Office Action Summary

10/672,181

DETAILED ACTION

FIG.1B

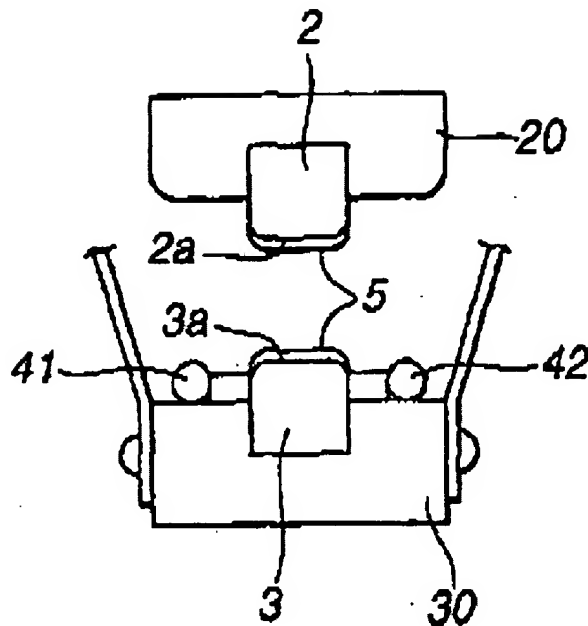
Hori et al illustrates in figure 1B a gas discharge laser having Fluorine gas, column 13 lines 16-20 and having a pair of discharge electrodes (2) and (3) [applicant's lower portion], where each electrode includes a film (5) [applicant's upper curve region] disposed on the discharge parts (2a) and 3(a) [applicant's footprint]. Column 19 lines 11-12, describes the film (5) as an insulator and in column 19 lines 43-46 discloses the

film as a halogen-resistant substance made of copper fluoride [applicant's comprising copper]. In column 19 lines 17-24 Hori discloses, different metals used for the main discharge electrodes, which includes brass [where brass has benefit of applicant's CIP].

However, Ujzdowski et al discloses in column 7 lines 25-29, the use of aluminum bronze as the electrode [applicant's copper alloy].

Therefore, it would have been obvious to a person of ordinary skill in the art at the time of the invention to replace the electrode Ujzdowski et al with the electrode of Hori et al because it is more resistant to fluoride attacks than brass, column 7 lines 25-29 of Ujzdowski et al.

In column 20 lines 5-21 Hori et al discloses a method of bonding the film (5) to the electrodes [applicant's two pieces of material].
